**PARCEL G REMOVAL SITE EVALUATION
WORK PLAN**

**FORMER HUNTERS POINT NAVAL SHIPYARD
SAN FRANCISCO, CA**

June 2019

DCN: CH2M-9000-FZ12-0013

Figure 4-1
Impacted Buildings and
Background Locations
 Parcel G Work Plan
 Former Hunters Point Naval Shipyard
 San Francisco, California

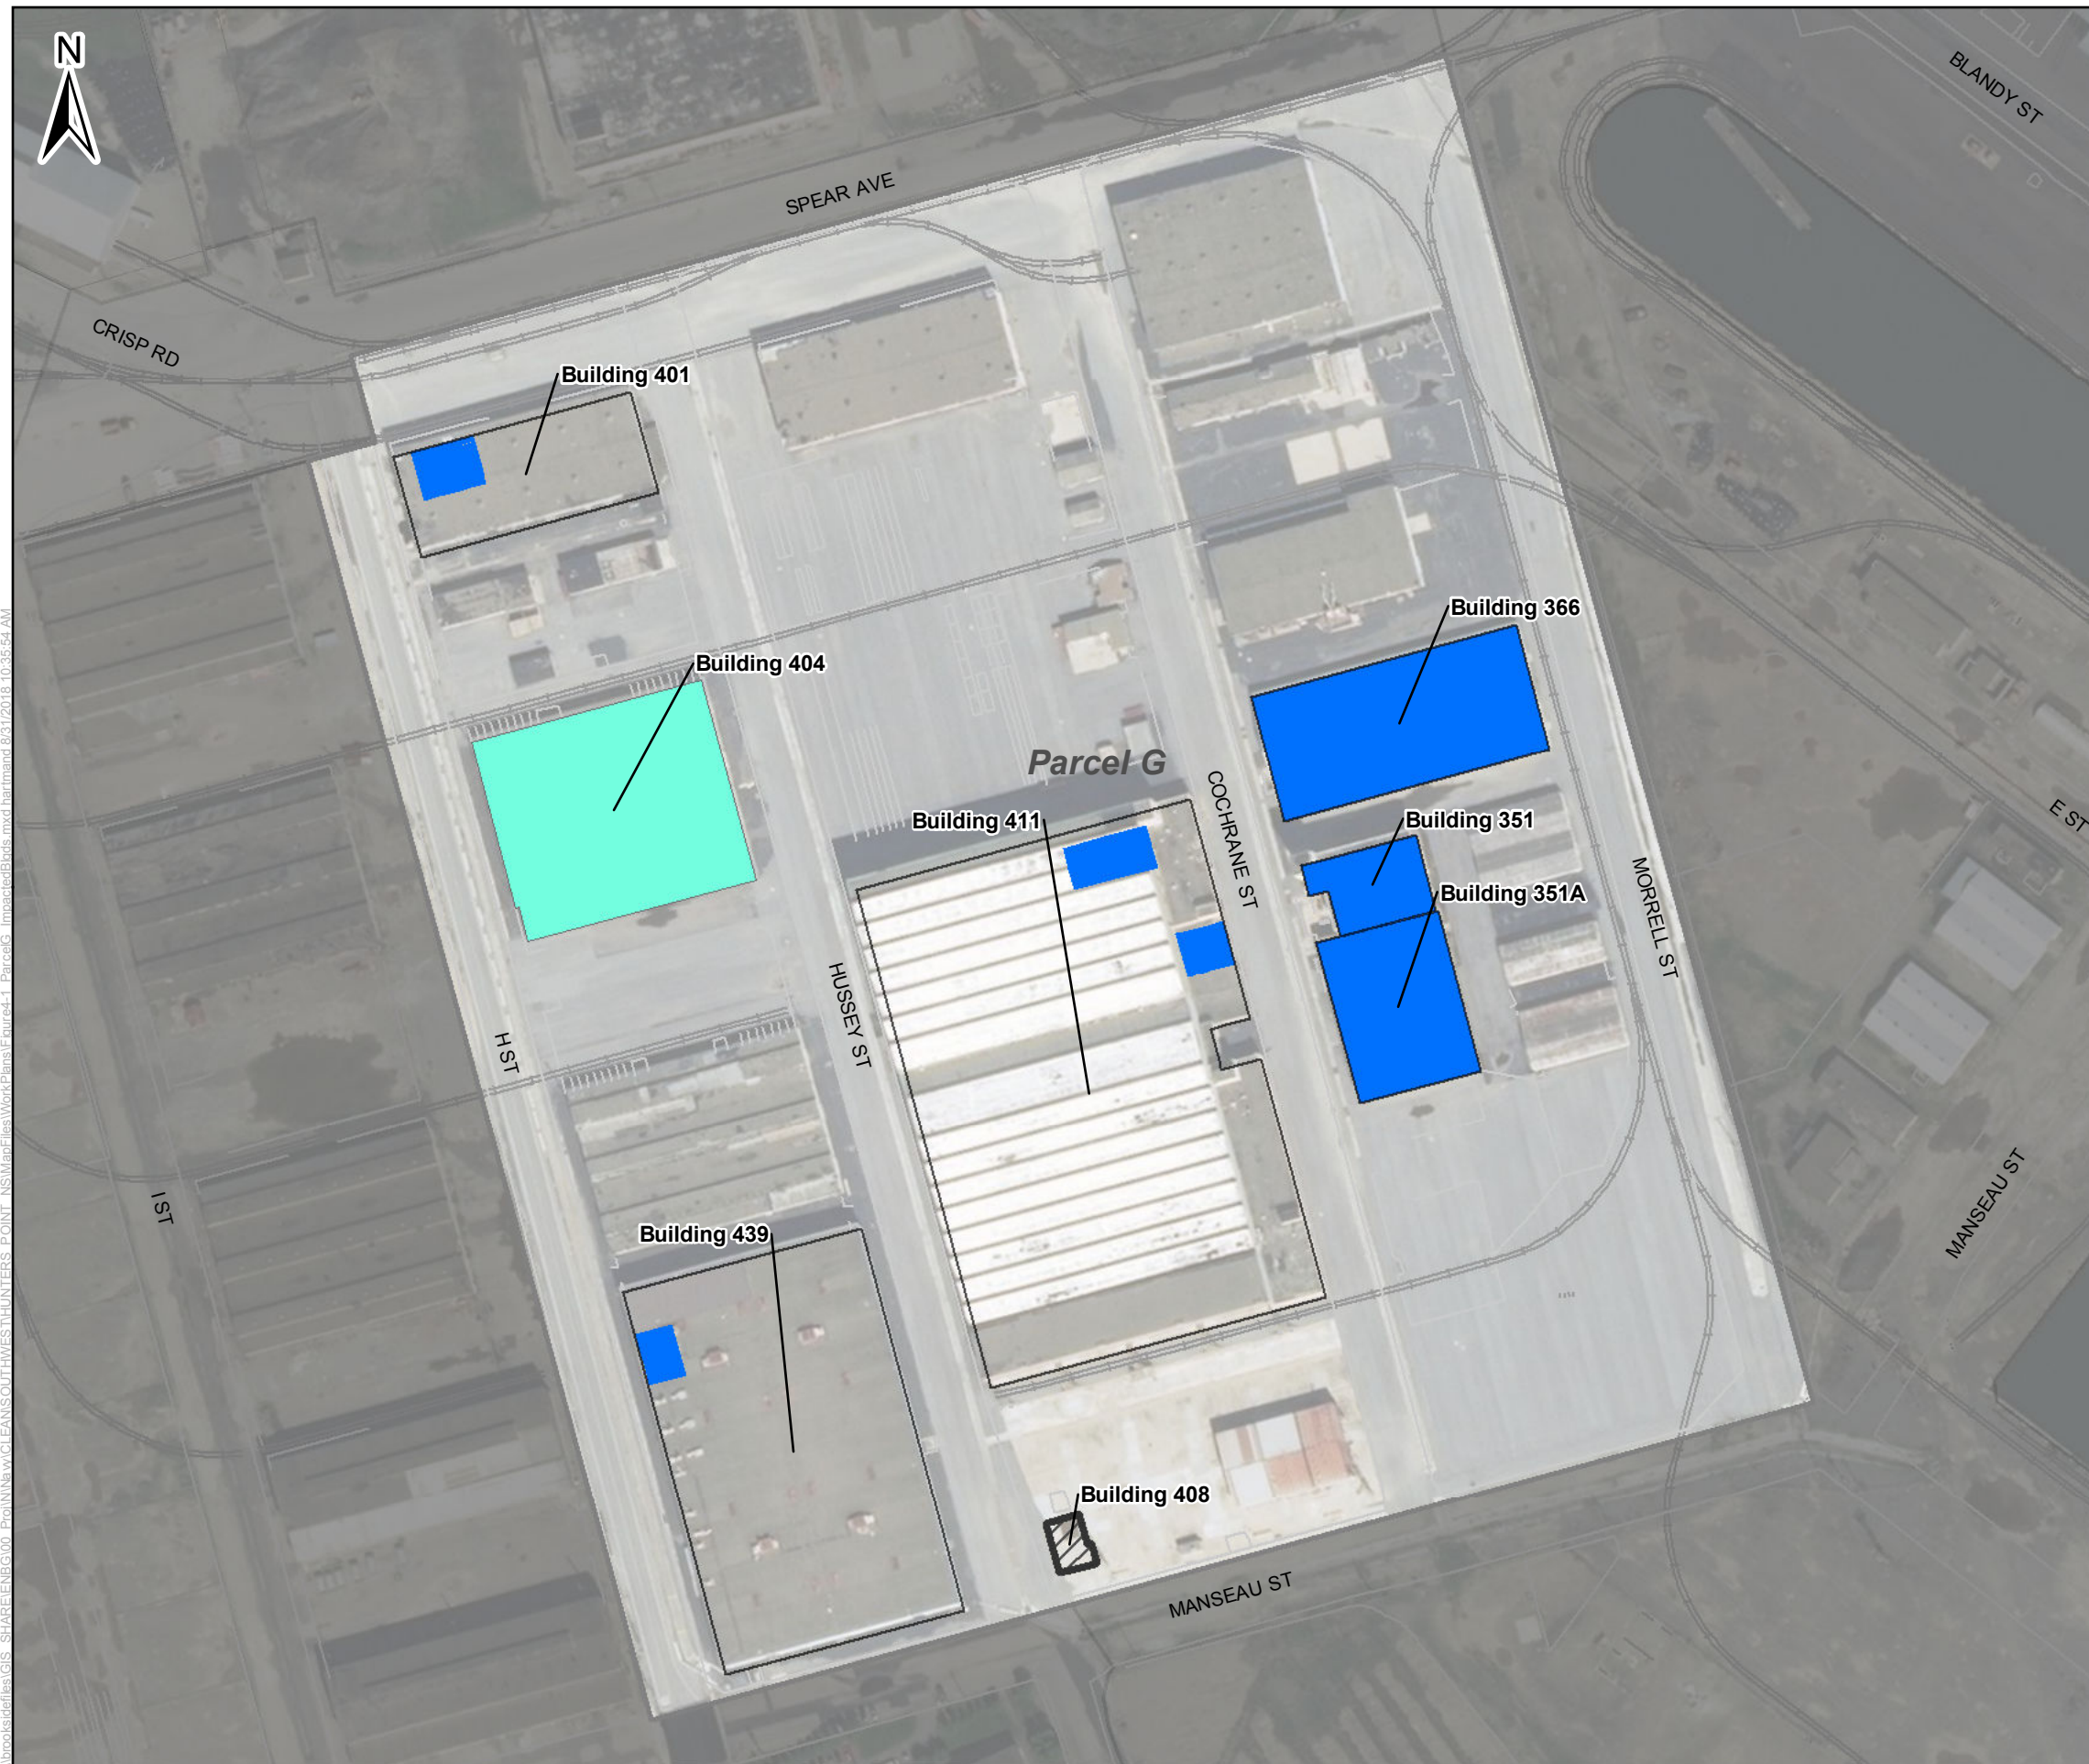
Figure 4-1 amazing background reference area is in an admittedly impacted building, a few feet away from parts of the building admitted to be impacted!!

In addition, according to Figure 4-1, building background reference samples will be taken from Building 401, a building that has been radiologically impacted. This location is apparently justified by the Navy’s assertion that the first floor was not impacted. It defies the imagination that there is not a more suitable location. Perhaps from a building no part of which was ever impacted? Like many other portions of the Draft Plan there is a paucity of information, this time on the building background sample selection process. It should be fully described, including justification for the site or sites selected.

In Figure 4-1 of the Work Plan, we are shown the proposed location from which to take samples to determine background for buildings. This building, Building 401, was previously designated impacted (in the Parcel G Record of Decision, as well as in the Building 401 Final Status Survey Report). Taking background measurements from a contaminated area is just asking for inflated background numbers... which the Navy would probably like very much.

Figure 4-1 of the Draft HPNS Parcel G Work Plan displays the selected background location for buildings, located within the northeastern corner of Building 401. However, earlier in this same document, as well as in the Parcel G ROD and the building 401 Final Status Survey Report (FSSR), it is indicated that the entirety of the building was designated as impacted. In the FSSR, carried out by Tetra Tech, it is reported that “non-licensed radioactive materials, such as check sources, electron tubes, and other radioluminescent devices” as well as “several gauges and dials containing radium-226,” were identified inside Building 401. Following that discovery, a radiological survey was conducted by Tetra Tech, the entity whose suspect work inspired this entire retesting plan. It makes no sense why one area of the building is required to be re-tested

Figure 4-4
Building 366 Floor Plan
 Parcel G Work Plan
 Former Hunters Point Naval Shipyard
 San Francisco, California

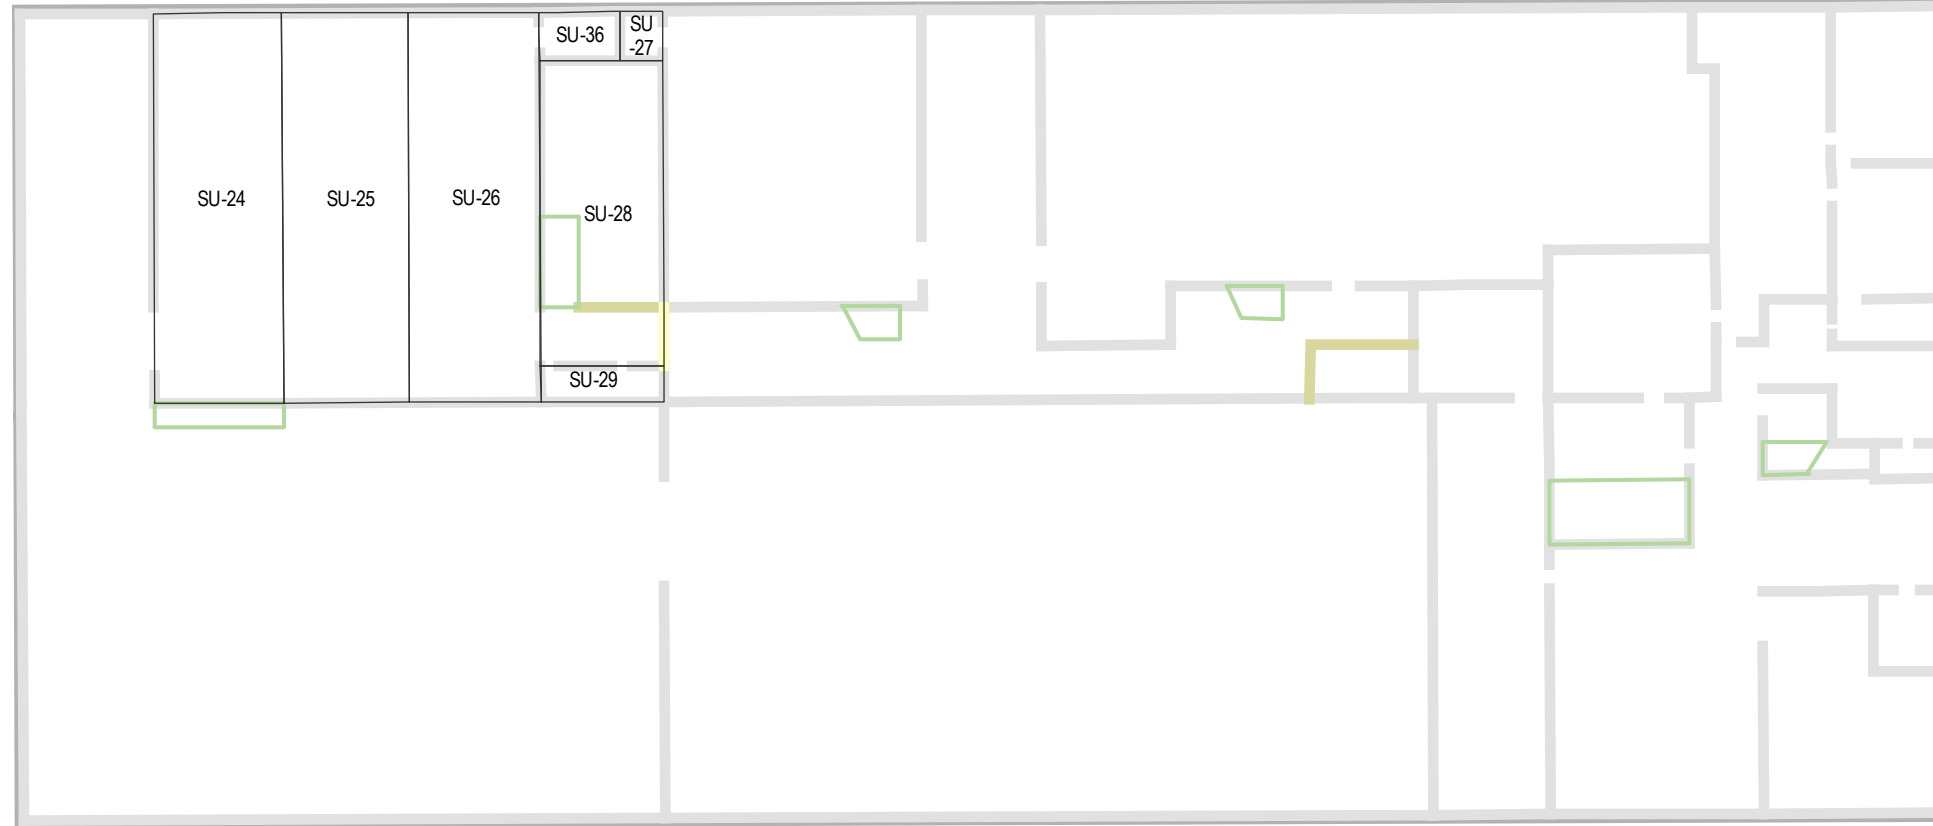
3. Response to EPA General Comment 15, item a: The response addresses the comment. Please also revise Figure 4-4, Building 366 Floor Plan, to include the Class 3 Survey Unit (SU) #69.

3. Response to GC 3 (Original GC 15a): The response indicates a note will be added to state that Survey Unit (SU) 69 consists of building exterior surfaces; however the note that is proposed for addition to Figure 11-7 does not indicate that the SUs for the exterior of Building 366 are designated as Class 3. Please revise the appropriate figures in the Parcel G Work Plan and in the Sampling and Analysis Plan (SAP) to indicate which SUs will be investigated as Class 3 areas.

A note will be added to work plan Figure 4-4 and SAP Figure 11-7 to state, “SU 69 consists of the building exterior surfaces.”

The note in Figure 4-4 of the work plan will be updated to state, “SU 69 consists of the building exterior surfaces, designated as Class 3.” Changes to the SAP at this time would require additional and unnecessary reviews and cause further lengthy project delays.

For Building 366, a note will be added to work plan Figure 4-4 and SAP Figure 11-7 to state, “SU 69 consists of the building exterior surfaces. SU 70 is a mezzanine level in the southwest corner of the building. If it can be safely accessed, it will be surveyed as a Class 1 SU.” In addition, the following text will be added to the end of the first paragraph of Section 4.4.3.3 of the work plan: “...The building exterior (SU 69) is a Class 3 SU. The mezzanine level in the southwest corner of the building is SU 70, which will be surveyed as a Class 1 SU if it can be safely accessed.”
